S E R V I C E N O T E

83215A RF Interface**Serial Numbers:** 0000A00000 / JP2KA00260**Modification corrects halting ANT IN output due to momentary power failure****To Be Performed By:** Agilent-Qualified Personnel**Parts Required:**

Figure 1.

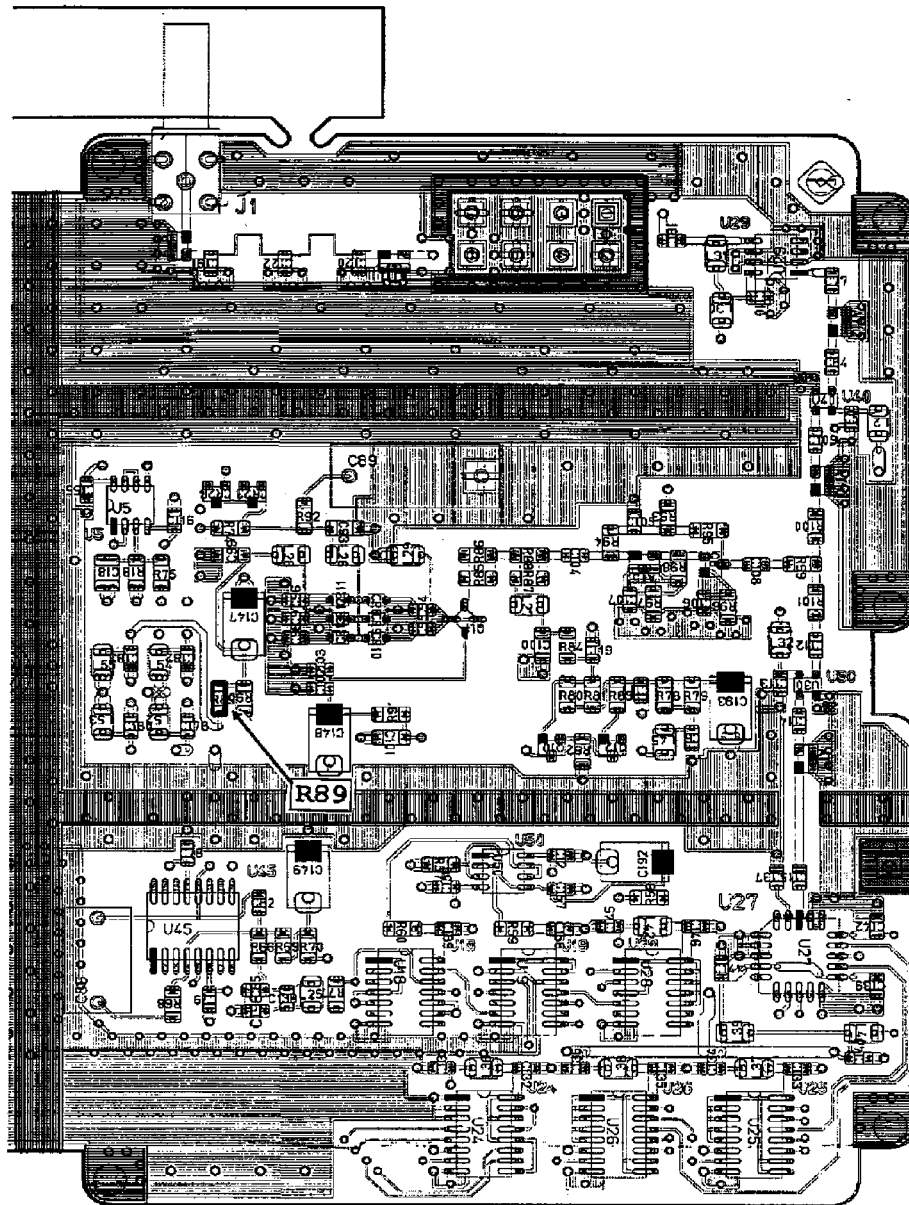
After 30 minutes warming up, ANT IN output is stopped when a momentary power suspension is occurred. The trouble is due to error on designing VCO circuit.

There are two PC board versions for A4 board. Replace A4R89 with the correct one by referring to either figure 1 or figure 2 according to your board revision.

Part No.	Qty.	Description
0699-1387	1	RES 6.81K 1%
